PUBLIC UTILITIES COMMISSION

November 25, 2020

RE: Valley-Ivyglen 115kV Subtransmission Project (VIG) – Minor Project Refinement No. 3 Request: Notice to Proceed- (NTP-) 2 Supplemental Work Areas, Access Roads, and Gabion Structure

Figure 1. Proposed Re-route of VIG7 Fiber Optic Line from Underground to Overhead.

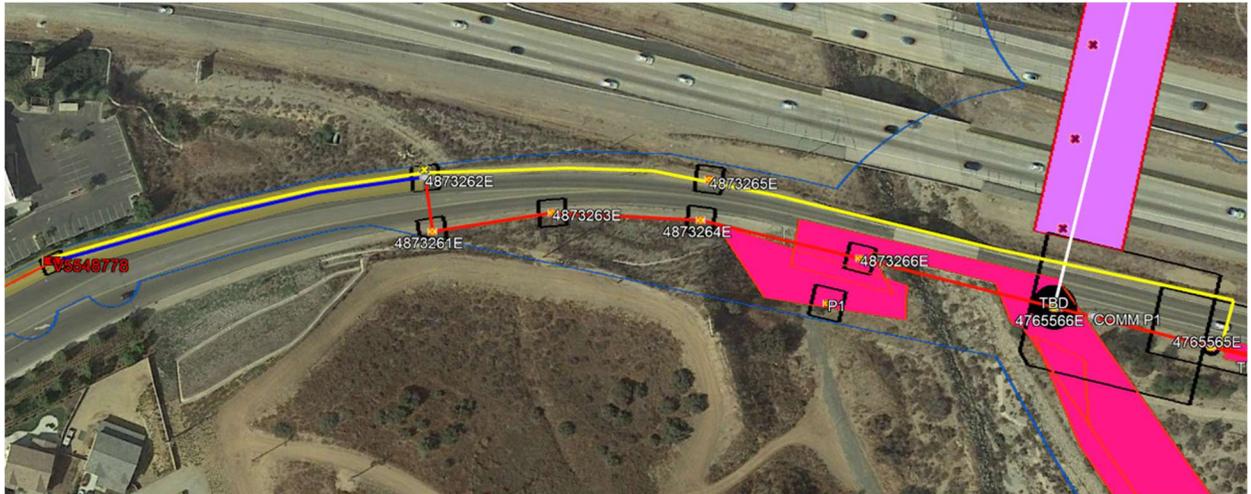
Furthermore, work under MPR No. 3 includes a modification to a portion of the telecommunications fiber optic line for Segment VIG7 on De Palma Road, located in Riverside County. Currently, a portion of the telecommunications fiber optic line for segment VIG7 is licensed for installation underground along De Palma Road as described in the FEIR (Section 2.3.1.2). SCE is proposing to instead install 955 feet of fiber optic line overhead on existing electrical utility poles along the south side of De Palma Road, and across De Palma Road to an existing structure on the north side. The existing utility poles were not present at the time the FEIR was prepared. Approximately 430 feet of undergrounding would still be necessary to take the fiber optic line from the westernmost distribution pole on the north side of De Palma Road to the existing vault at the southern end of VIG 8. These activities would occur within the general disturbance area (see Attachment A, Figure 1).

The proposed revision to the telecommunications fiber optic line in VIG7 (De Palma Road) from underground to overhead would place 955 feet of fiber optic line onto existing electrical utility poles currently supporting 33-kV and 12-kV distribution conductors. The overhead fiber optic line would span six poles and would be positioned approximately 26 feet above the ground and 17–30 feet below the 12-kV distribution conductor. The proposed fiber optic line would be visible to drivers travelling along De Palma Road and on the I-15 freeway located 115 feet to the north, as well as to residents in homes located approximately 450 feet to the southwest. The fiber optic line would be non-specular and smaller in diameter than the 33-kV and 12-kV conductors above it. The fiber optic line would be visually indistinct relative to these electrical conductors and would not have a substantial adverse effect to a scenic vista, scenic resources, or to the visual character of the location.

10. SCE shall notify CPUC after completing MPR No. 3 work activities including use of access roads, installation of the gabion structure, and re-route of VIG7 fiber optic line from underground to overhead and provide photos of the restored additional work disturbance areas. In addition, in the event that new disturbance is foreseen, for maintenance or other activities, SCE shall notify CPUC for evaluation and approval.
